APPLICATION BY NATIONAL GRID ELECTRICITY TRANSMISSION
FOR AN ORDER GRANTING DEVELOPMENT CONSENT FOR THE SEA LINK PROJECT
(REF: EN020026)

DEADLINE 1

**WRITTEN REPRESENTATION BY THE PORT OF
LONDON AUTHORITY**

Figure 3 – Sunk Pilot Diamond where a water depth of -22m CD must be safeguarded

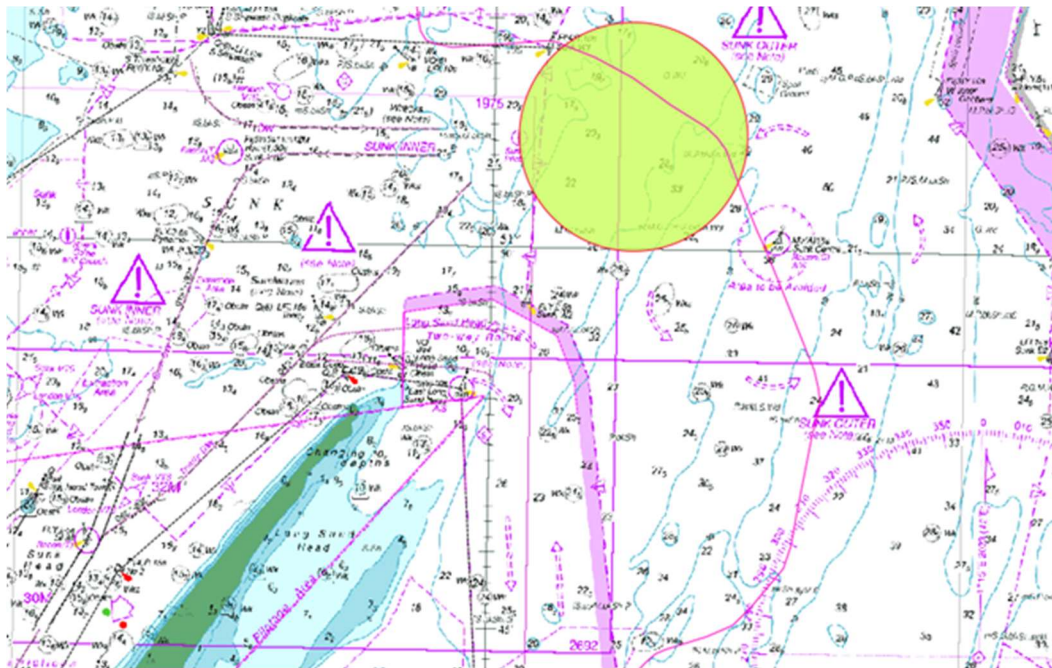
- 5.2 The Marine HVDC cable route is shown as Work No. 6 on the Work Plans - Offshore [APP-023]. The Marine HVDC cable route passes close to the Sunk Pilot Diamond (approximately 2 km at the closest point at KP37) as shown on figure 6.4.4.7.A.2 of the ES Figures Marine Navigational Risk Assessment Part 1 of 2 [APP-283]. Pilotage is compulsory for large vessels within the London Pilotage District and this area is critical for entry and exit of deeper draughted vessels into/from the Port of London with the boarding and landing of pilots taking place in the vicinity of the Sunk Pilot Diamond rather than at the specific point shown on

figure 6.4.4.7.A.2. The actual location will be based on a number of factors, including traffic density, wind strength and direction and tidal conditions.

- 5.3 The depth of the cables in the vicinity of the Sunk Pilot Diamond; the approach to cable laying and repair; cable protection and cable crossings are all critical in this area. Consistent with other cable schemes in the area, the PLA requires future access for vessels with a draught of 20m and accounting for 10% under keel clearance this means that a water depth of 22m below Chart Datum (“CD”) must be maintained by Sea Link in the vicinity of the Sunk Pilot Diamond. The ability to maintain this depth is required regardless of existing water depths. Figure 3 below shows the cables in red and an area in green where a water depth of 22m below CD must be protected to allow the boarding and landing of deeper draughted vessels to take place unconstrained at the Sunk. If water depths of -22m CD are not safeguarded then this will significantly reduce the area within which the boarding and landing of deeper draughted vessels can take place and may severely restrict their access in and out of the port. There would be an increased risk of collision for very large vessels if they are required to manoeuvre for boarding and landing within a more restricted area. This area is exactly the same as safeguarded in the North Falls Offshore Windfarm Project (see Project EN010119 Deep Water Route Cable Installation Areas (Future Dredging Depth) Plan [REP6-055]).

- There is no mitigation in relation to designing out planned cable joints in the areas shown in figures 3 to 5 above.

Activity	Summary of PLA's Position	Securing Mechanism
Cable installation, maintenance, operation and decommissioning	Safeguarding of current and future depths: 22m Sunk Pilot Boarding Area 12.5m Long Sand Head 12.5m North East Spit And in all cases making allowance for an over-dredge tolerance of 0.5m	Design Requirement DML Protective Provisions for the PLA Certified Plan
Cable installation and maintenance	The most effective method of cable laying in terms of speed and ability to achieve the required cable burial depth must be used	oNIP
Cable Crossings	Safeguarding of current and future depths: 22m Sunk Pilot Boarding Area 12.5m Long Sand Head 12.5m North East Spit And in all cases making allowance for an over-dredge tolerance of 0.5m	Design Requirement DML Protective Provisions for the PLA Certified Plan

Figure 4 – Long Sand Head where a water depth of -12.5m CD must be safeguarded

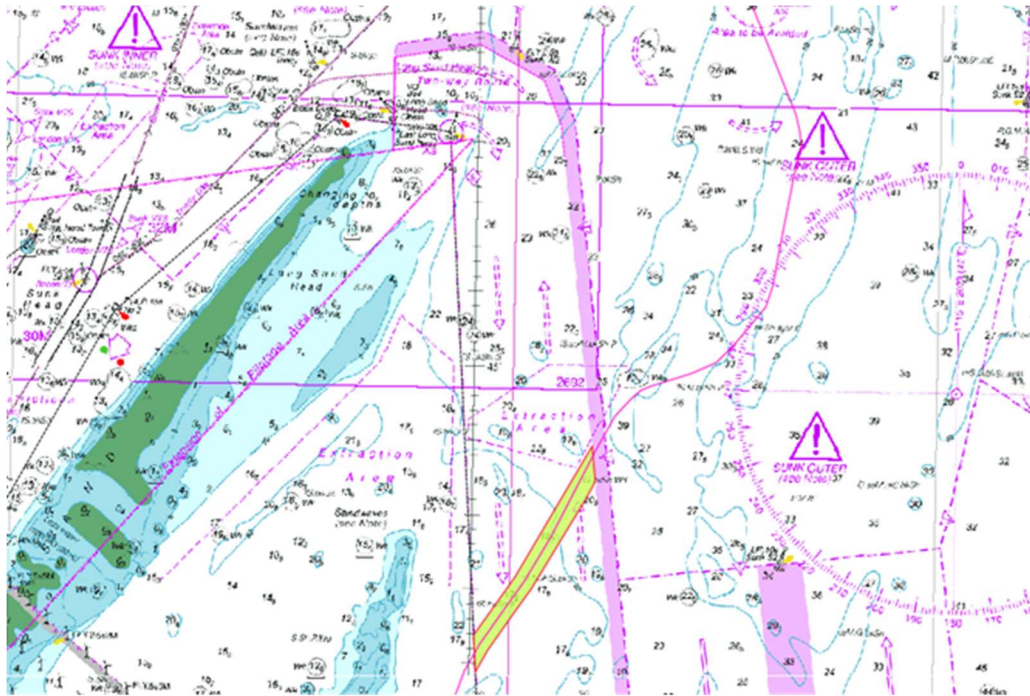
- 5.4 Continuing south, the cables then cross the Long Sand Head Two Way Route between approximately KP60 and KP65. This route feeds into the Trinity Deep Water Route and allows less deep draughted vessels that are entering or exiting the Port of London to take a pilot at the North East Spit and avoid travelling up to the Sunk pilot station via the Sunk roundabout. This flexibility is particularly important during periods of disruption to the Sunk routes, either due to adverse weather closing the Sunk pilot station or due to construction and maintenance activities of various planned cables. The depth of the Sea Link cables where they cross the Long Sand Head Two Way Route; the approach to cable laying and repair; cable protection and cable crossings are all critical in this area. A water depth of 12.5m below CD must be maintained by Sea Link in the area shown in green on figure 4 in order for vessels that use this route to continue operating without additional constraint to those already in existence around the Long Sand Head.

Figure 5 – North East Spit where a water depth of -12.5m CD must be safeguarded

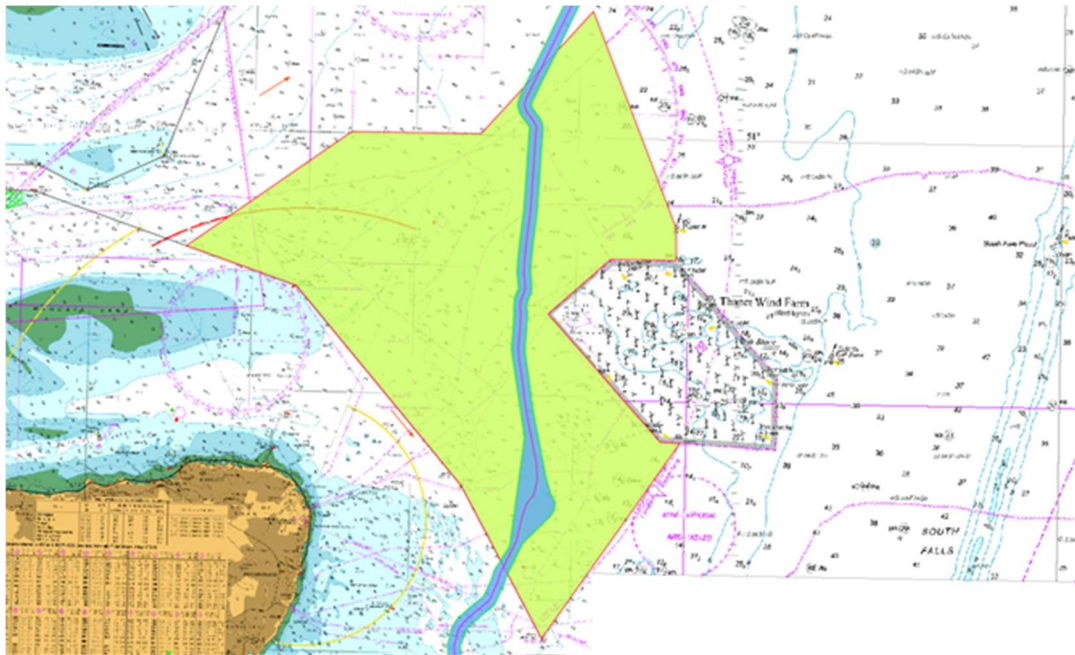
- 5.5 Continuing further south again, the cables pass through an area known as the North East Spit. Within this area the Tongue Pilot Diamond is located approximately 80m to the east of the offshore scheme at KP 90 and the North East Spit Pilot Diamond is located 3.9 km to the west at KP 97. As outlined above, boarding and landing of pilots takes place in the general vicinity of these pilot diamonds and not at the specific points shown on the plans. The depth of the cables at the North East Spit; the approach to cable laying and repair; cable protection and cable crossings are all critical in this area. Figure 5 below shows in green the area where a water depth of 12.5m below CD must be protected. The ability to maintain this depth is required regardless of existing water depths. If water depths of -12.5m CD are not safeguarded then this will significantly impact the area where the boarding and landing of vessels can take place and may ultimately prohibit some vessels from using the North East Spit for boarding and landing.

- 5.6 The Tongue deep water and hazardous anchorages are used as a staging area by vessels coming to and from the Port. Depths in the vicinity of the anchorages must be preserved so as not to compromise the ability of deep draughted vessels to enter and exit the anchorages
